## USB Type-C ENGINEERING CHANGE NOTICE

### Title: USB Type-C ECR Vconn Requirements Applied to: USB Type-C Specification Release 1.2

## Actual Change (a). Section 4.4.3 VCONN

**Figure Error! No text of specified style in document.-18 Passive Cable Electronic Marker State Diagram**

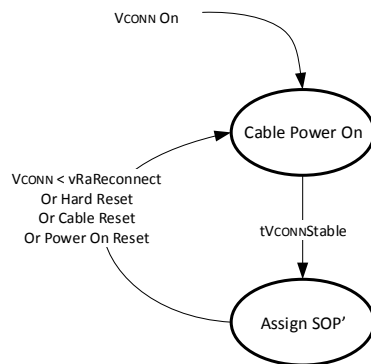
### (b). Add new Cable State Machine Requirements Section

Figure 4-18 illustrates the passive cable Electronic Marker connection state diagram. Figure 4-19 illustrates the active cable Electronic Marker connection state diagram.

This state appears in Figure 4-18 and Figure 19. This is the initial power on state for the Electronic Marker in the cable when VCONN is applied.

The Electronic Marker in the cable shall present Ra when no VCONN is applied.

The Electronic Marker in the cable shall power on may continue to present Ra in this state.

The cable shall not respond to SOP' and SOP'' commands in this state.

The Electronic Marker in a passive cable shall transition to Assign SOP' when it has completed its boot process. The Electronic Marker in the passive cable shall transition to Assign SOP' within tVCONNStable, Table 5-4.

The Electronic Marker in the passive cable shall weaken or remove Ra if it has not already done so.

The Electronic Marker in the passive or active cable shall transition to Cable Power On upon sensing VCONN less than vRaReconnect defined in Table 4-5 or upon a Power On Reset event.

The Electronic Marker in the passive cable shall transition to Cable Power On upon sensing a Hard Reset or Cable Reset.

**Figure 5-6 Managed Active Cable Plug SOP' and SOP'' Assignment**

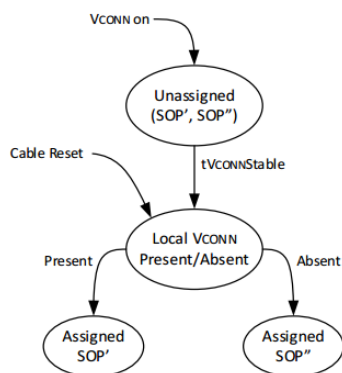
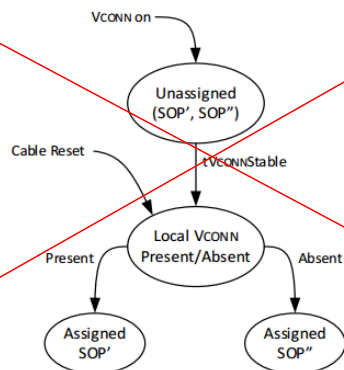
Commented [GWC4]: Figure is deleted.

Managed active cables shall implement the Cable State Machine defined in 4.5.2.4 and Figure 4-19.

Figure 5-7 Managed Active Cable

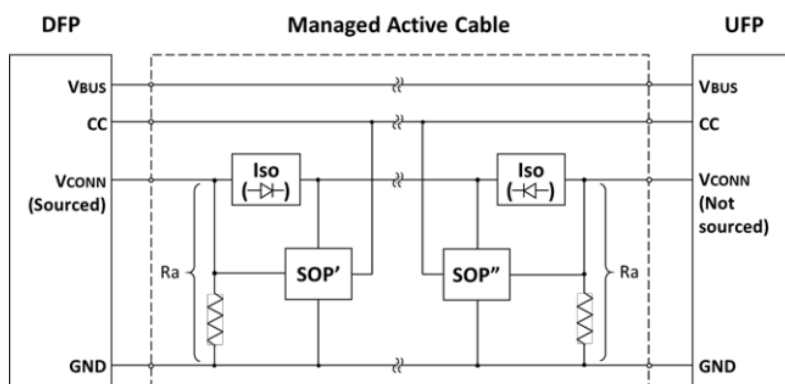
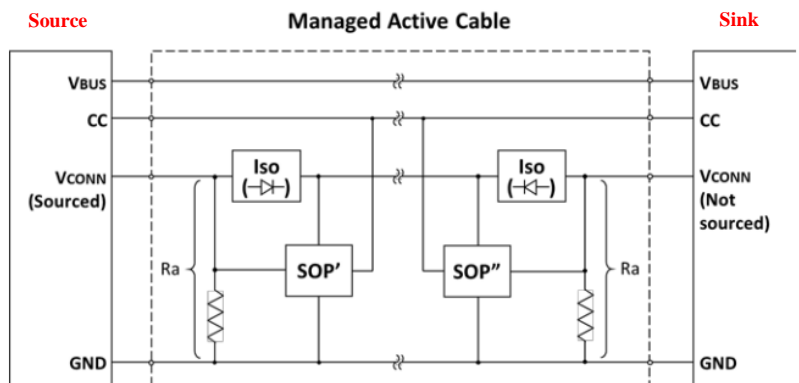
Figure 5-7 illustrates a typical managed active cable. The isolation elements (Iso) shall prevent VCONN from traversing end-to-end through the cable. [Ra](#) must be present when no VCONN is applied to allow the DFP to determine that VCONN is needed.
